NORTH LOGAN CITY
4.0 MG TANK DISTRIBUTION AND SUPPLY PIPELINES PROJECT
ADDENDUM #2

May 6, 2025

RATTLESNAKE HILL 4.0 MG TANK PROJECT

A FOUNDATION PLAN
SCALE: 3/32" = 1'-0" (22x34)

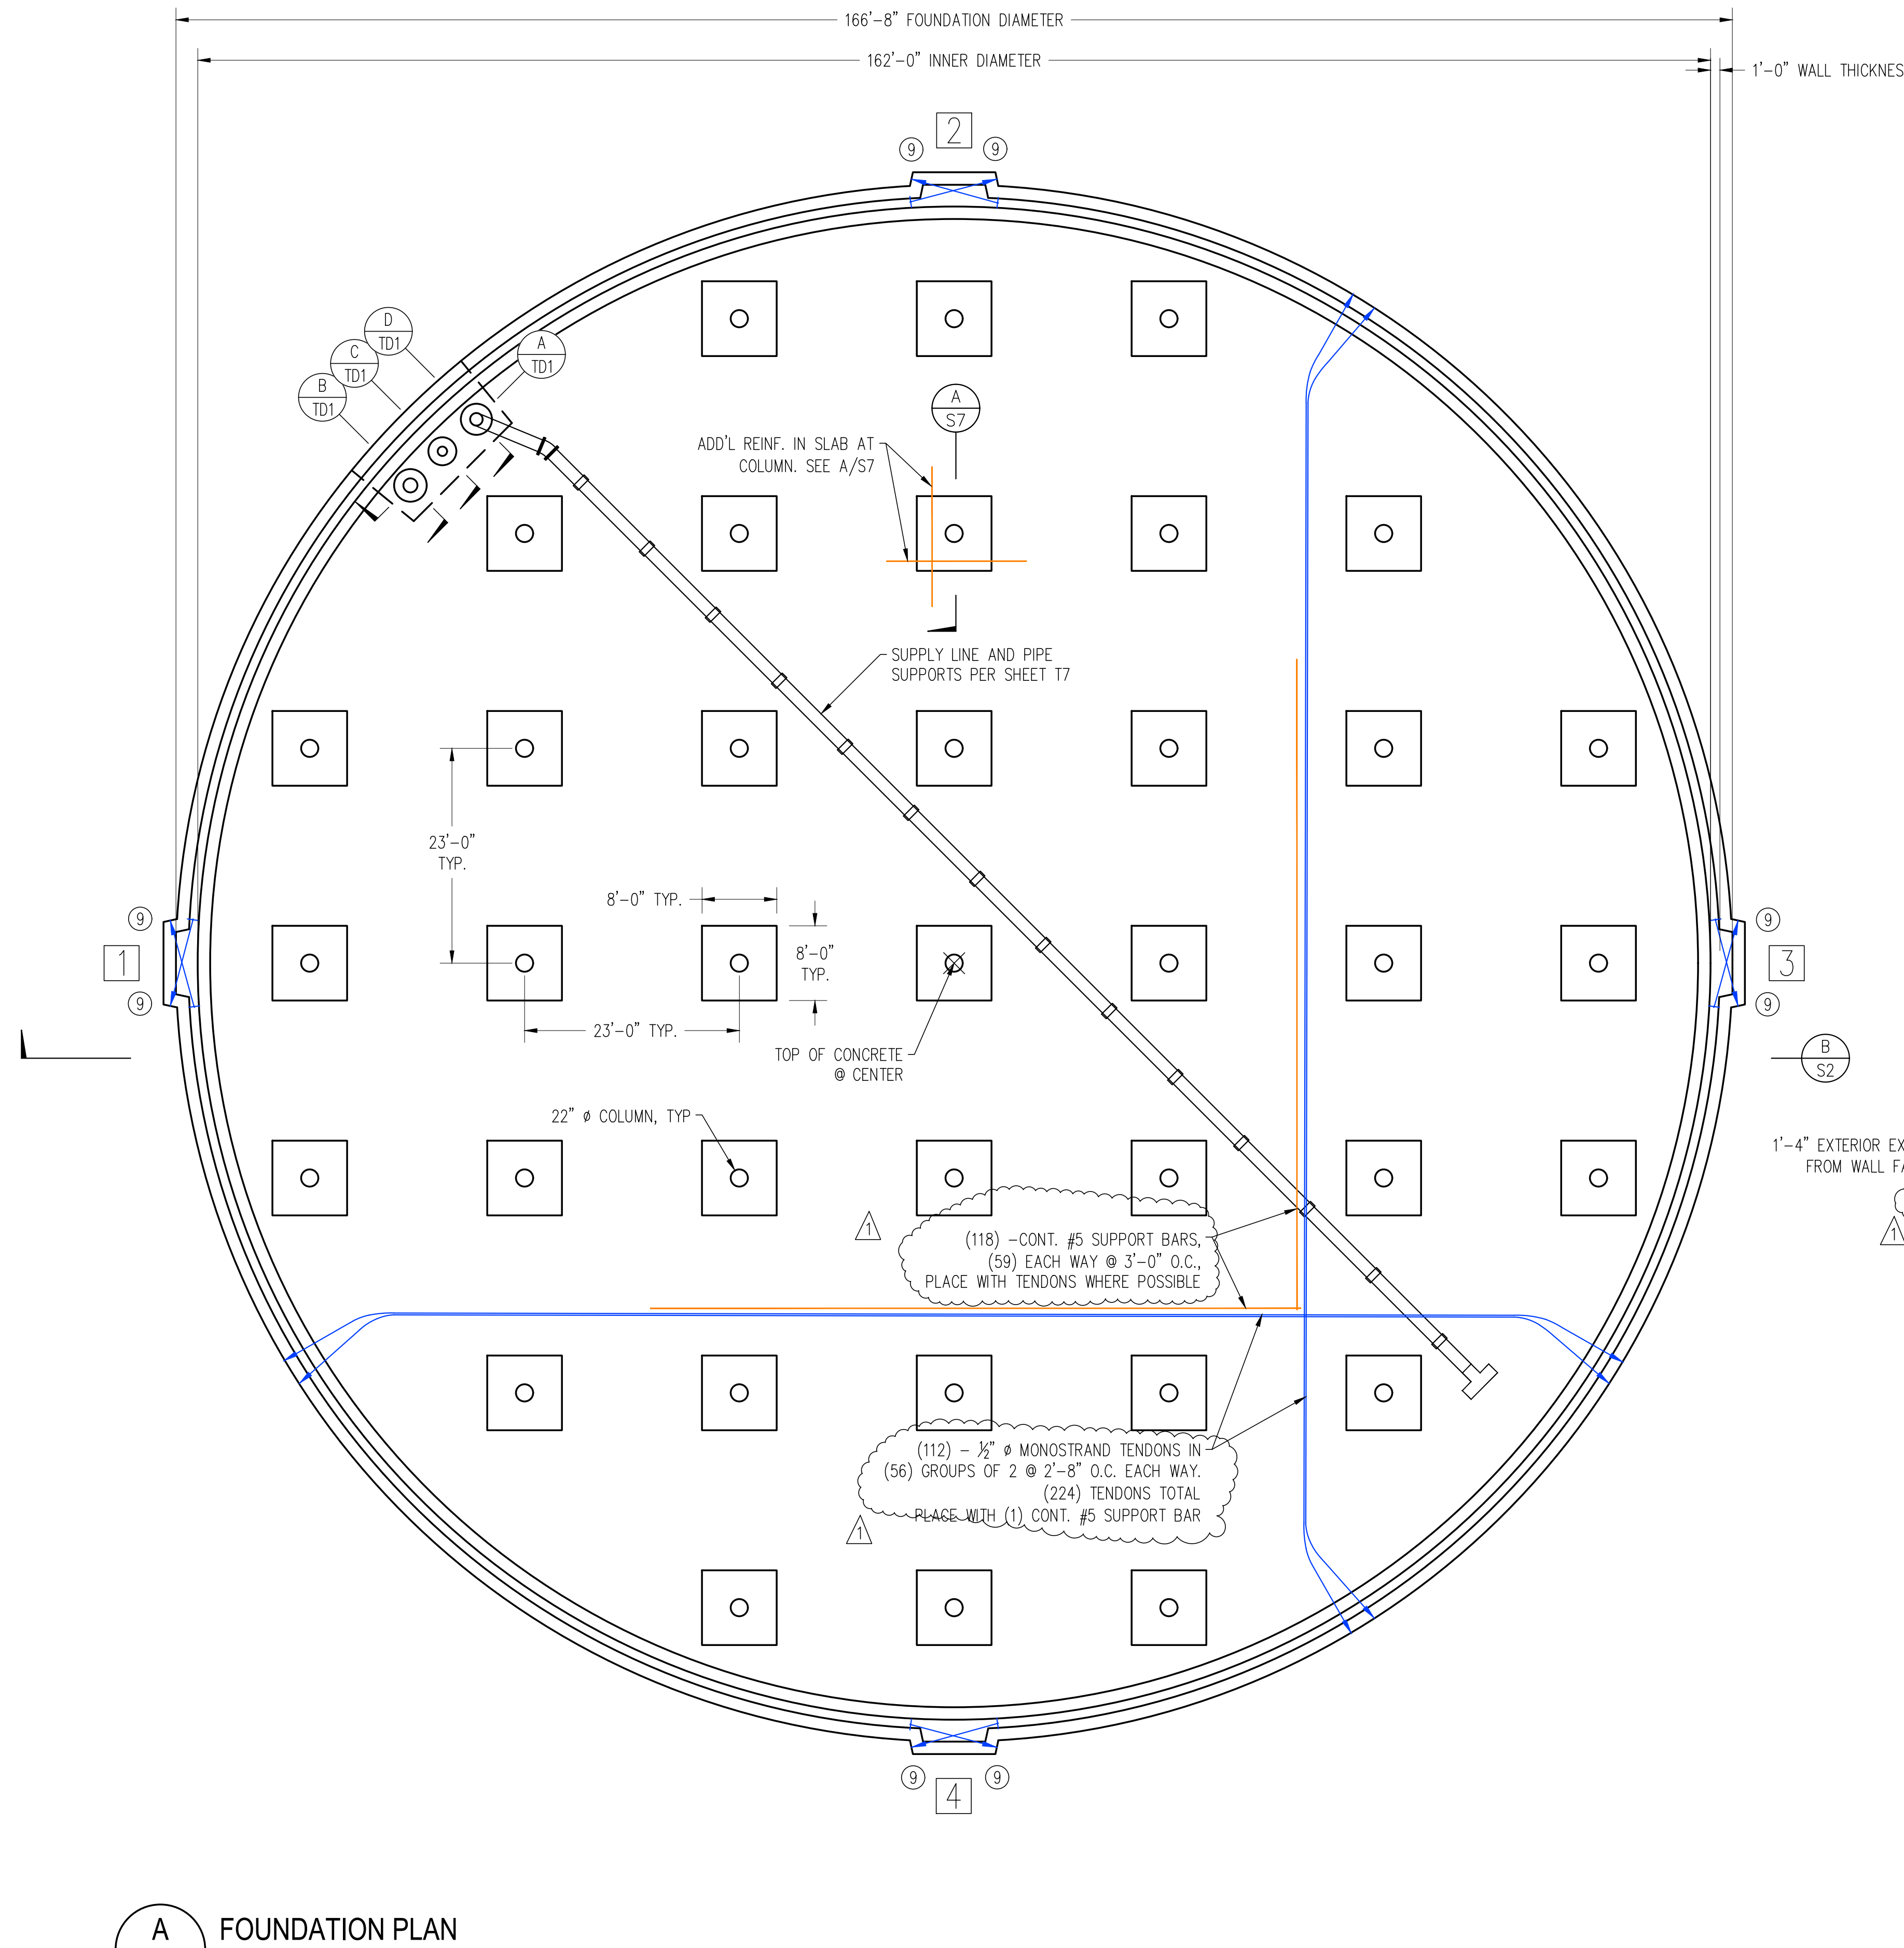
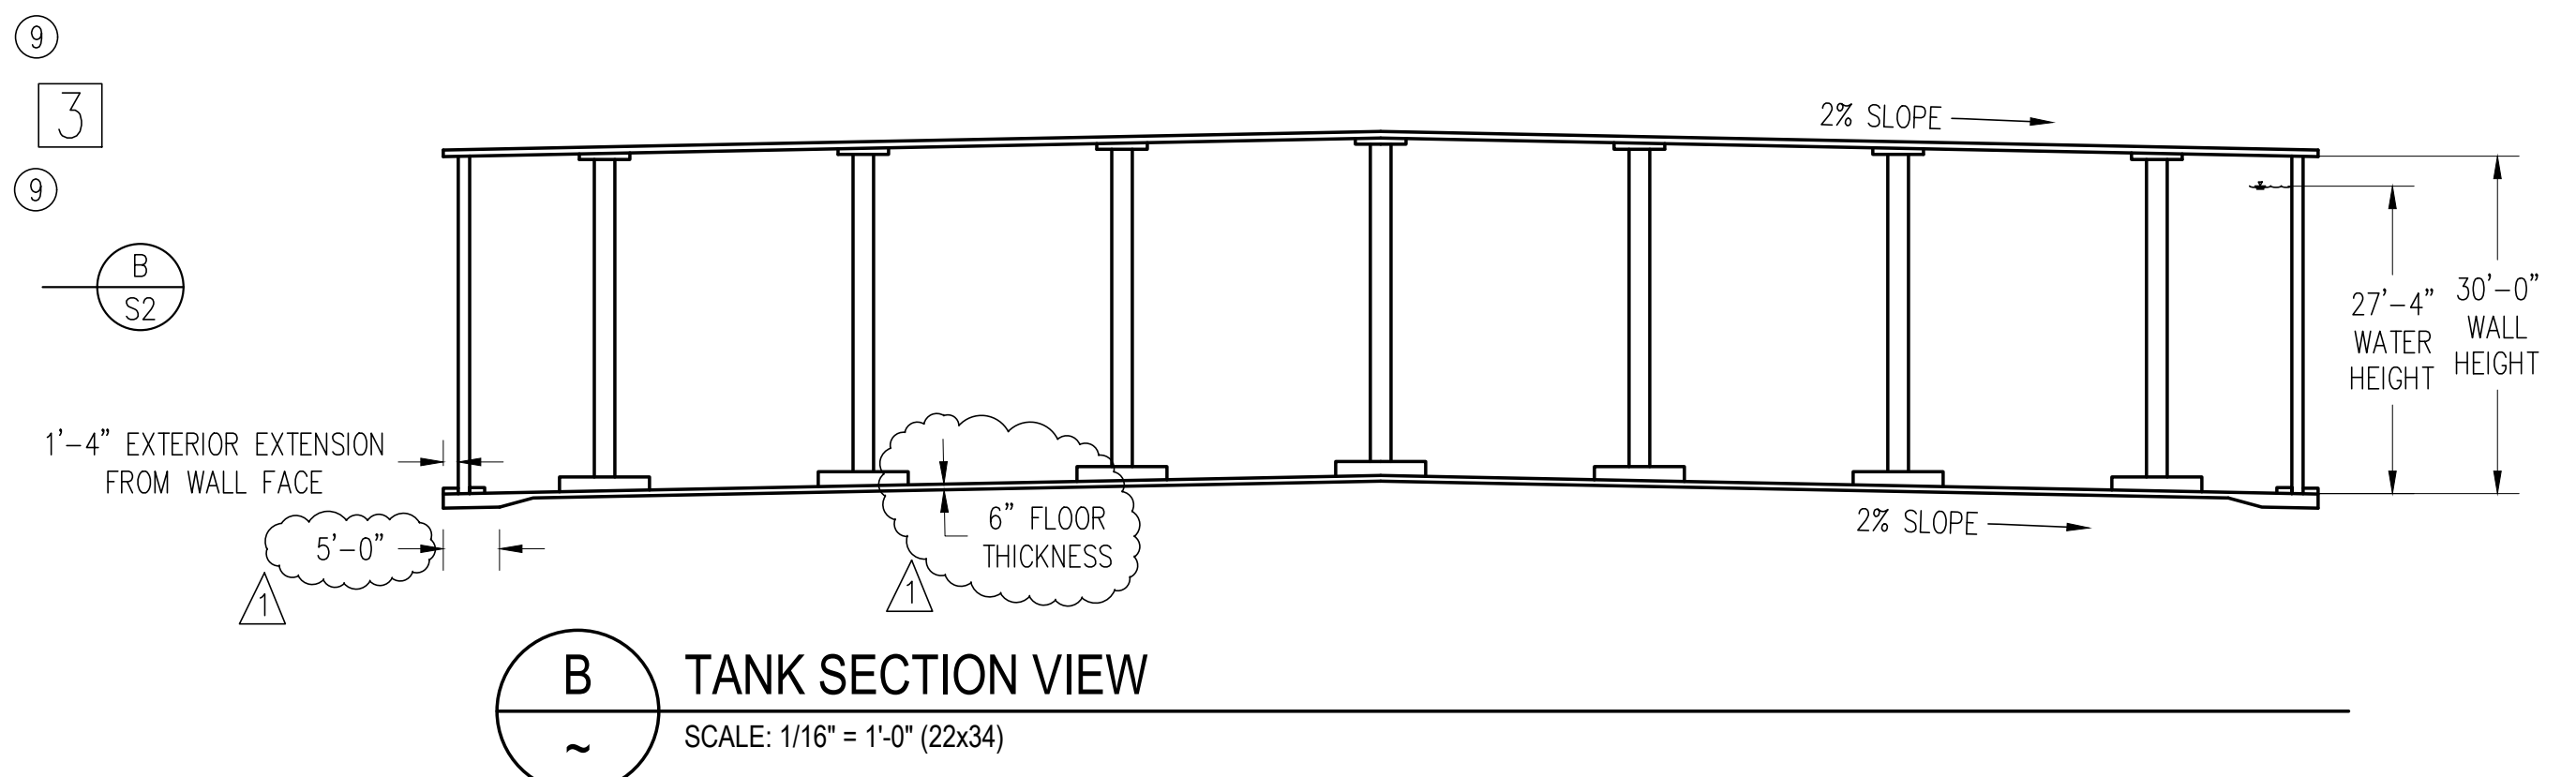
- 1) The concrete floor of the tank will be increased to 6" thick and additional reinforcement both traditional rebar and cable reinforcement has been added. Steve Hansen, the Structural Engineer, has provided the following updated structural sheets to make the alterations needed for the tank.

REV. NO.	SLAB REVISIONS	COMMENT	DATE
1			5/05/25
